City of Portland, Maine - Building or Use Permit Application

Permit No: 07-1216	Issue Date: 1/31/08	CBL: 433 H003001
-----------------------	------------------------	---------------------

Proposed Use: Single Family Home- Amendment to permit#070917 - Rebuild covered porch, new entrance 10' x 6', Bathroom addition and kitchen remodel	Proposed Project Description: Amendment to permit#070917 - Rebuild covered porch, new entrance 10' x 6', bathroom addition and kitchen remodel
---	---

FRONT ENTRYWAY NOT TO SCALE

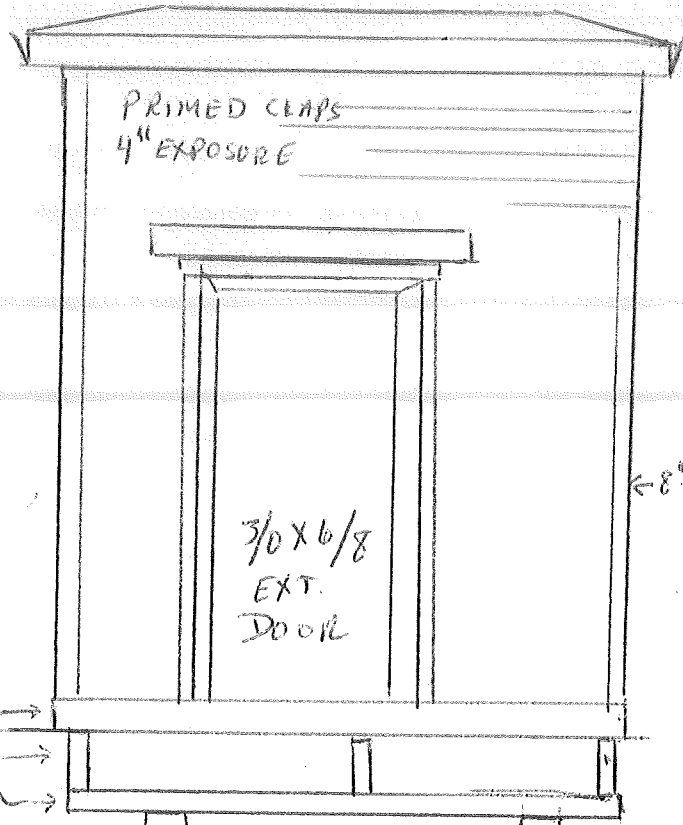
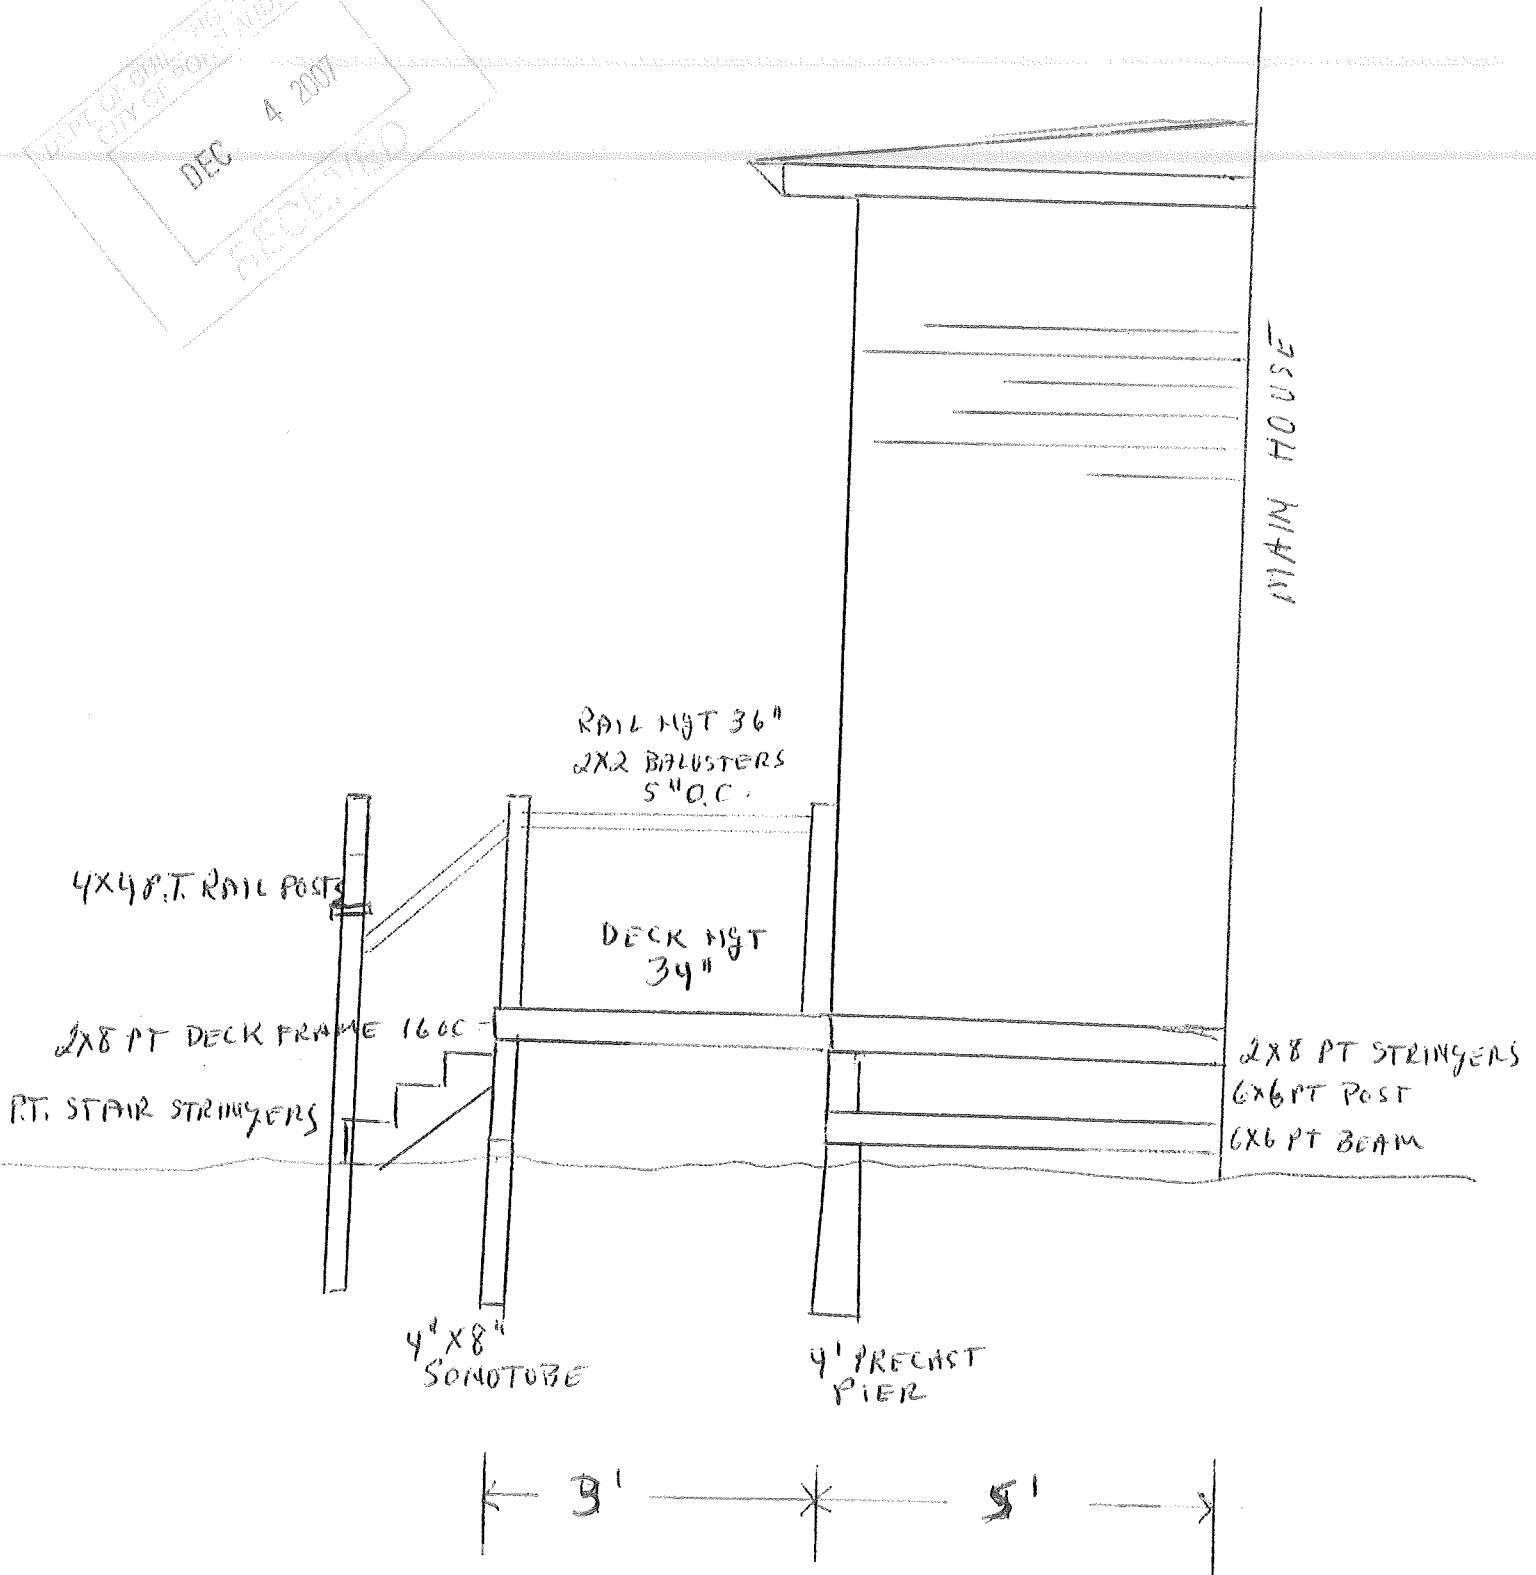
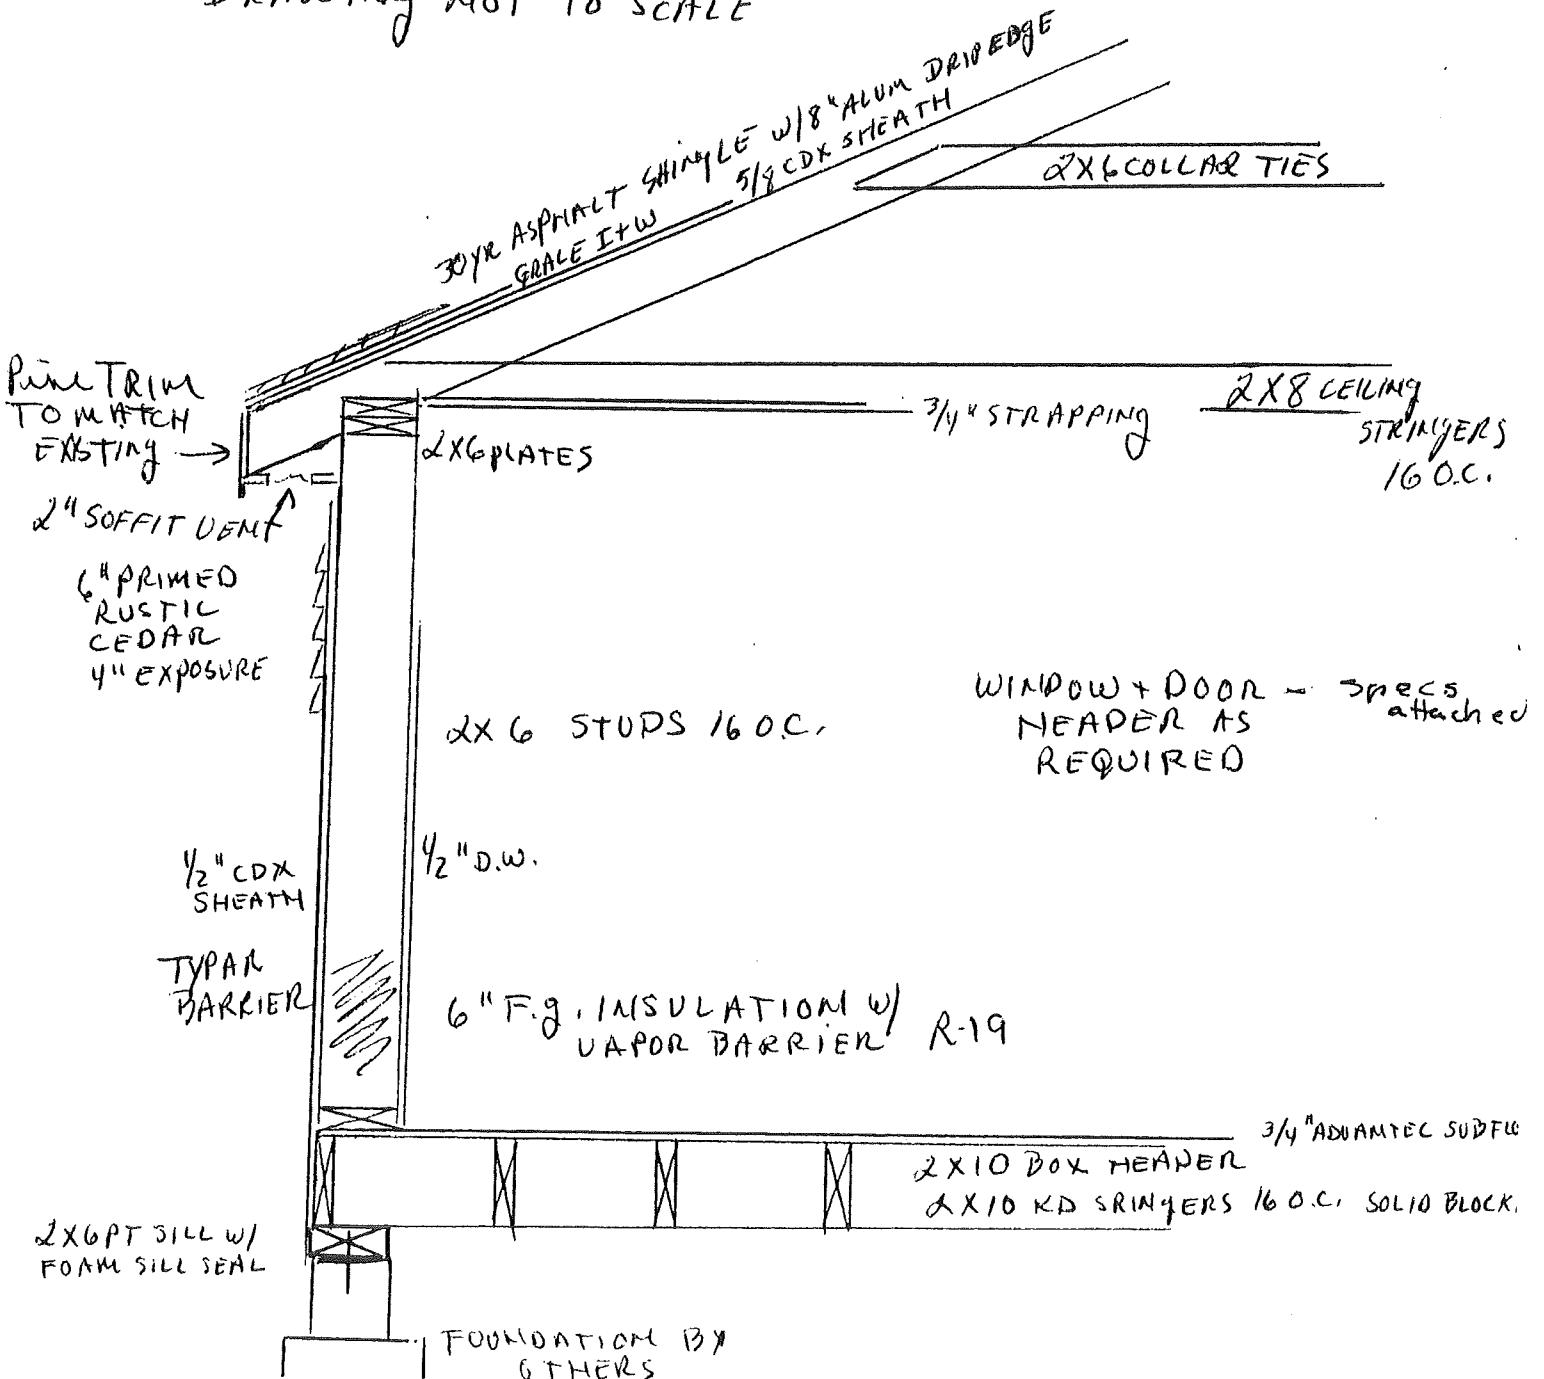
- 1) As discussed during the review process, ballusters must be spaced with less than a 4" opening between each.
- 2) Open risers are permitted, provided that the opening between treads does not permit the passage of a 4" diameter sphere.
- 3) Fastener schedule per the IRC 2003
- 4) Railing/ballaster detail required, collar ties required, and new deck and stair details prior to ammendment work commencement
- 5) Separate permits are required for any electrical, plumbing, or HVAC systems. Separate plans may need to be submitted for approval as a part of this process.
- 6) Permit approved based on the plans submitted and reviewed w/owner/contractor, with additional information as agreed on and as noted on plans.

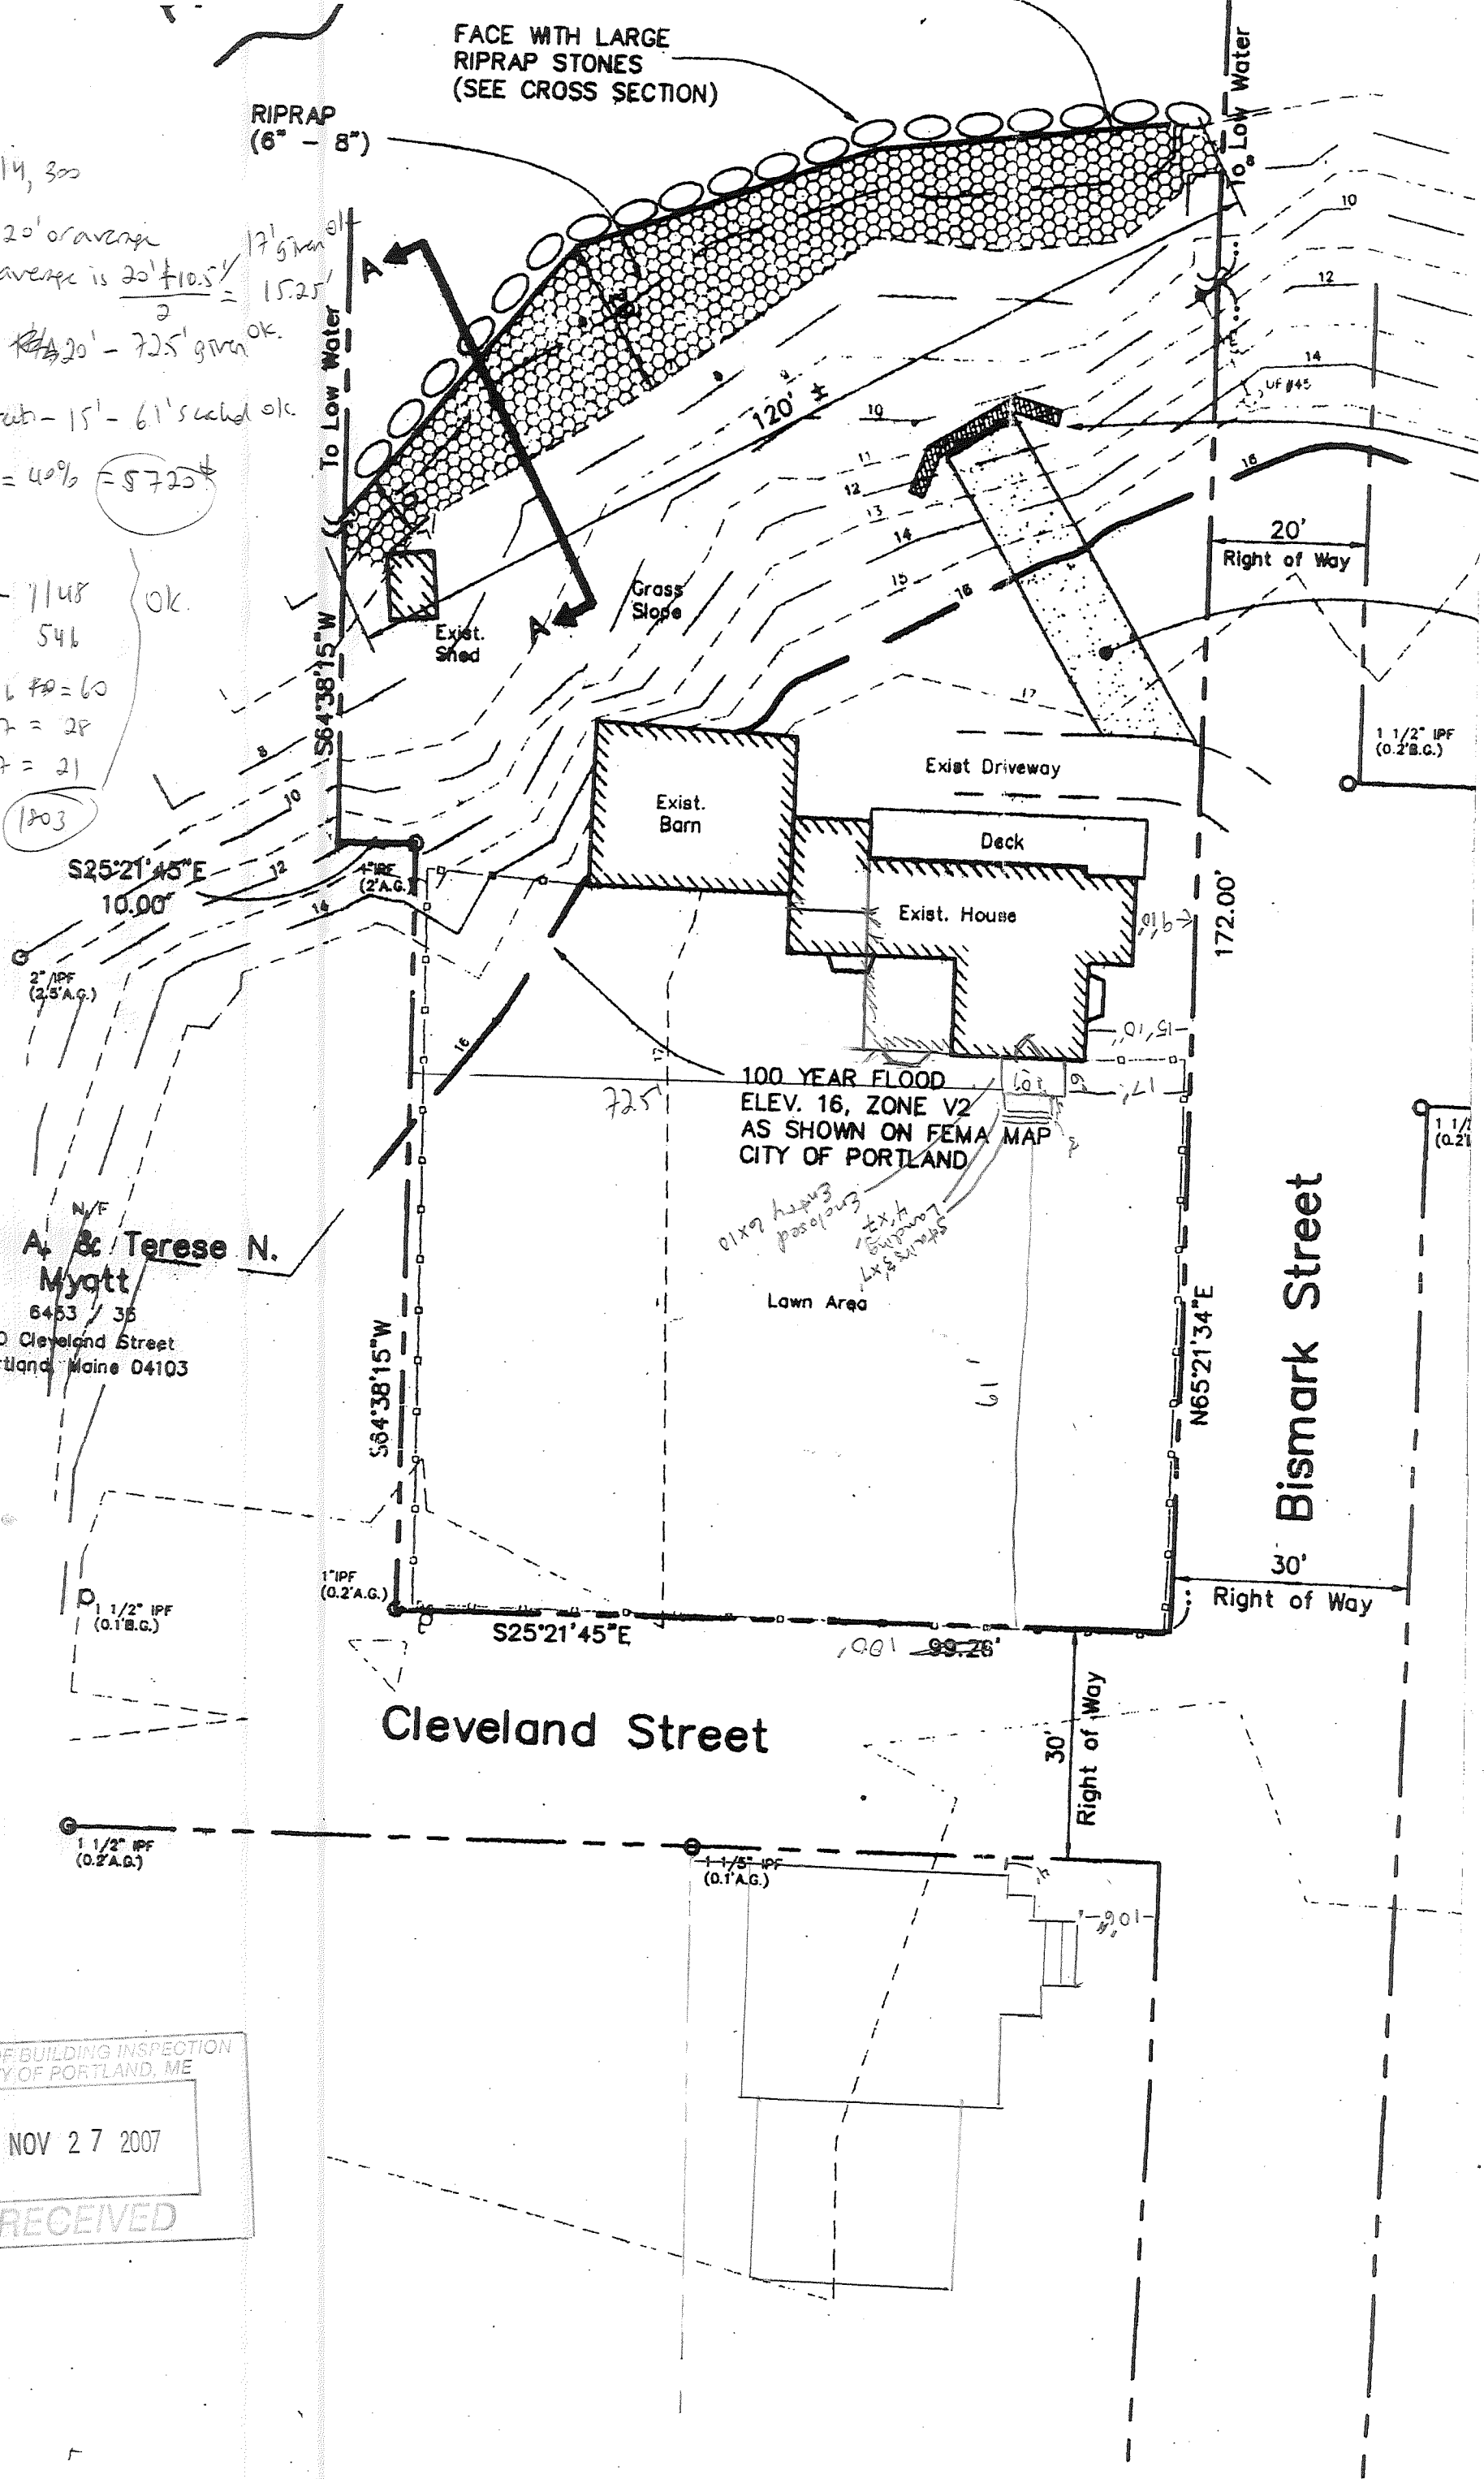
lots in = 14, 300

front setback 20' or average

average is $\frac{20' + 10.5'}{2} = 15.25'$

rear setback - ~~20'~~ 72.5' given ok.

Side on side street - 15' - 61' setback ok.

lot coverage = 40% = 5725'

Remove - deck + stair landing

+
Bring revised plan

Cond of Additional Sonotube

Add full Bath in
existing 1st floor 6x10 area,

Beam Connectors add collar ties
on Posts + to Posts

Railing + Handrail detail -
Add joist hangers
